Federal Aviation Administration

Memorandum

Subject: Application of Obstacle Accuracy Uncertainty, FAA Order 8260.52, United States Standard for Required Navigation Performance (RNP) Approach Procedures With Special Aircraft and Aircrew Authorization Required (SAAAR)

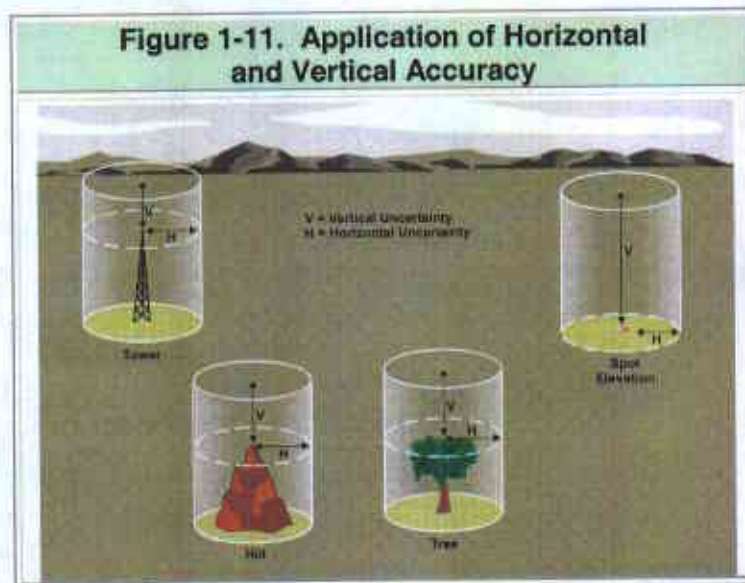
The first sentence of paragraph 1.15.2, Application of Vertical and Horizontal Accuracy Uncertainty, contains an extra word that confuses the intent of the paragraph. The word "code" should not appear in the sentence. The paragraph should read as follows:

1.15.2 Application of Vertical and Horizontal Accuracy Uncertainty.

Apply the obstruction vertical and horizontal accuracy values to all obstructions. From a 3-dimensional perspective, a point described by latitude, longitude, and elevation can be evaluated as a cylinder when applying both vertical and horizontal accuracy values (see figure 1-11).

In other words, the documented vertical error value is added to the obstacle height and the documented horizontal error value is added in all horizontal directions. The resulting cylinder represents the defined airspace that the obstacle could occupy. It could be anywhere in the cylinder; therefore, the entire cylinder is considered an obstacle.
